Clinch River Nuclear Site  
NRC Docket No. 52-047

Subject: Response to Request for Additional Information Number 4, eRAI-8857,  
Regarding Population Distribution in Support of Early Site Permit Application  
for Clinch River Nuclear Site

Response to NRC Request for Additional Information Number 4, eRAI-8857

Figure 1, Distance to Urban Areas Near CRN Site

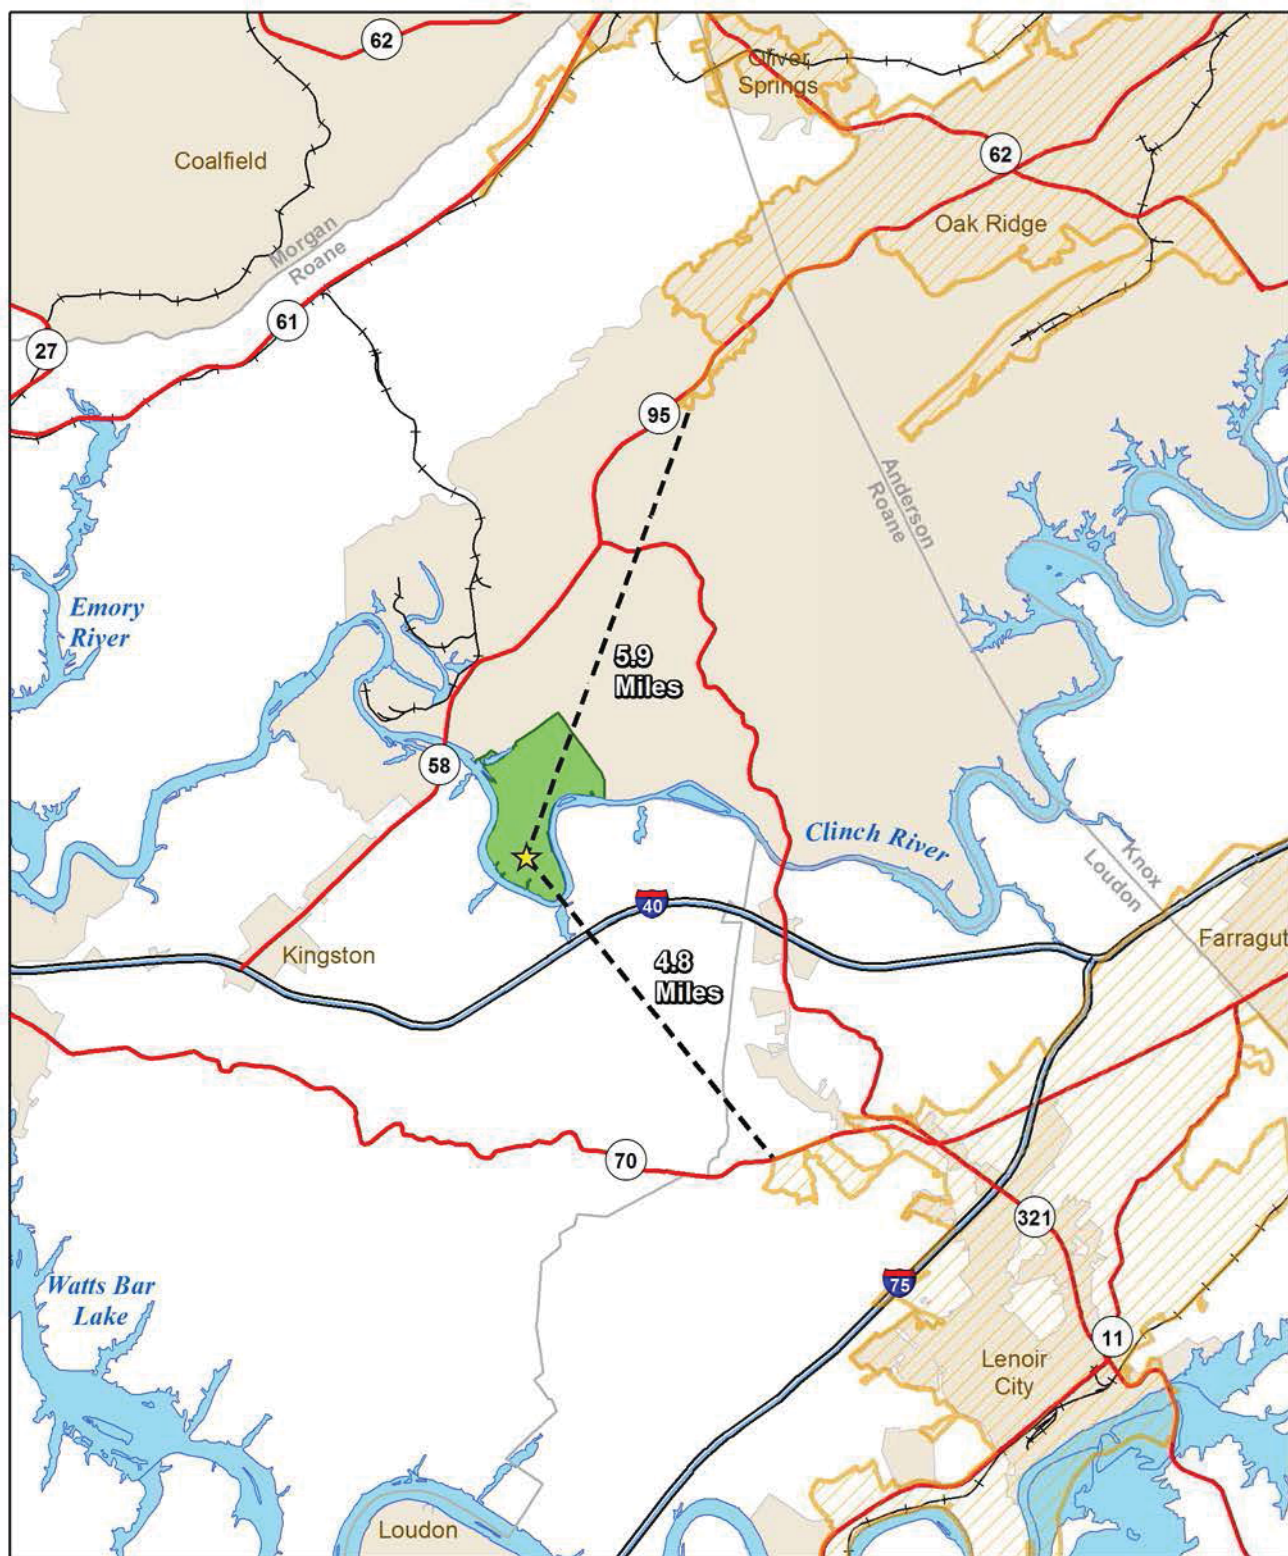
RG 1.206 provides guidance regarding the information that is needed to ensure that the information identified and evaluated to meet the siting criteria in 10 CFR 100.20(a) and 10 CFR 100.21(b). The applicant used USCB census-delineated urban areas in the region based on population density. The two urban areas identified are the Knoxville (4.8 mi southeast) urban area with the combination of smaller cities including LaFollette, Oak Ridge, Clinton, Loudon, Lenoir City, Alcoa, Maryville, Farragut, Rockwood, Seymour, and Knoxville; and the Cleveland (45 mi south-southwest) urban area with the combination of smaller cities including Calhoun, Charleston Hopewell, and Cleveland, Tennessee. The Knoxville and Cleveland urban areas had 2010 populations of 558,696 and 66,777 persons, respectively. The distances of these identified urban areas are much greater than the one and one-third times the distance from the site center point to the outer boundary of the LPZ.

The applicant considered meeting the population center distance requirement (10 CFR 100.21(b)), based on the distances from the site center point to the boundary of each of the two identified urban areas in Knoxville, Tennessee, which is 4.8 mi southeast and Cleveland, Tennessee, which is 45 mi south-southeast. Both of these population centers are much greater than the one and one-third times the distance from the site center point to the outer boundary of the LPZ. But the applicant followed an approach by using urban area designation with combination of smaller cities for complying with the population center distance of one and one-third times the distance from the reactor to the outer boundary of LPZ. This approach differs from the regulatory requirement, and could set a new precedent as it considers and combines various small cities of lesser than 25,000 people, rather than considers a city with a densely populated. This effectively changes the distances identified to meet the regulatory requirements. Although in this case the result may be more conservative, the analysis is still not in accordance with the regulatory definitions or requirements as specified in 10 CFR 100.21(b). Therefore, the staff requests the applicant in RAI 2.1.3-1 to revise the evaluation methodology in meeting the 10 CFR 100.21(b) regulatory requirement, solely based on considering the nearest city having population of 25,000 or more people.

There are no population centers located within the minimum population center distance required by 10 CFR 100 (e.g. one and one-third times the distance from the site center point to the outer boundary of the Low Population Zone (LPZ)). As described in the SSAR Subsection 2.1.3.5, there are only two urban areas within the region that meet the requirements to be considered population centers: Knoxville and Cleveland (Reference 1). These are located approximately 4.8 miles (mi) (southeast) and 45 mi (south southwest), respectively. As described in SSAR Subsection 2.1.3.5, the densely populated areas associated with the City of Oak Ridge and Lenoir City are included in the United States (U.S.) Census defined Knoxville Urban Area. Figures 1 and 2 illustrate the geographic relationship of the Knoxville Urban Area, the City of Oak Ridge and Lenoir City densely populated areas, and their distances to the CRN Site reactor. As noted in the figures, the densely populated portion of the Knoxville Urban Area attributed to the City of Oak Ridge is located approximately 5.9 miles north northeast. The portion of the Knoxville Urban Area attributed to the Lenoir City dense population areas is approximately 4.8 miles southeast. SSAR Figure 2.1-6 and Table 2.1-2 provide the population distribution surrounding the CRN Site by distance and direction. Both the table and the figure illustrate that the locations of the densely populated areas associated with these cities are beyond the distance required by 10 CFR 100.21(b) and satisfy Regulatory Guide 4.7, General Site Suitability Criteria For Nuclear Power Stations.

For the Clinch River region, all UAs and UCs having greater than 25,000 persons were identified as population centers and the distances reported in SSAR Subsection 2.1.3.5. None of the identified population centers were located within one and one-third times the distance from the site center point to the outer boundary of the LPZ.
